## **REVIEW OF DETERMINATION ASSESSMENT REPORT**

Application Number:	REV2019/0028
---------------------	--------------

Proposed Development:	Review of Determination of Modification 2018/432 Demolition works construction of attached dwellings and subdivision of land
Zoning:	Warringah LEP2011 - Land zoned R2 Low Density Residential Warringah LEP2011 - Land zoned R2 Low Density Residential Warringah LEP2011 - Land zoned R2 Low Density Residential Warringah LEP2011 - Land zoned R2 Low Density Residential Warringah LEP2011 - Land zoned R2 Low Density Residential Warringah LEP2011 - Land zoned R2 Low Density Residential Warringah LEP2011 - Land zoned R2 Low Density Residential

The photograph below illustrates the views enjoyed by the property to the east, No.2/15 McDonald Road, looking to east:

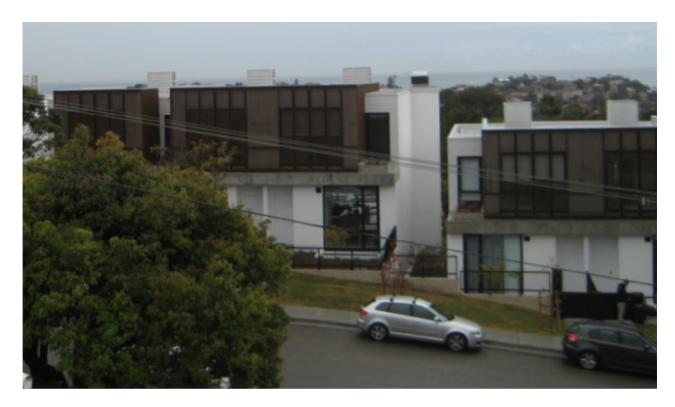
All the above properties enjoy district and ocean views in an arc from the north-east (towards and over Curl Curl Headland) to the south-east (towards North Head).

The views that will be affected are those obtained over the roof of the development, where the AC units protrude. These affected views consist of district views of the suburbs of Freshwater and Curl Curl, and views of the ocean and the horizon.

While the AC units are relatively small structures, they break up and interrupt what would otherwise be clear and intact views of the ocean and the horizon. These interruptions give the impression of view loss greater than a simple percentage calculation.

No. 2/15 McDonald Street - Moderate No.17 McDonald Street - Moderate No.182 Wyndora Avenue - Negligible No.32 Coles Road - Negligible No.31 Coles Road - Negligible
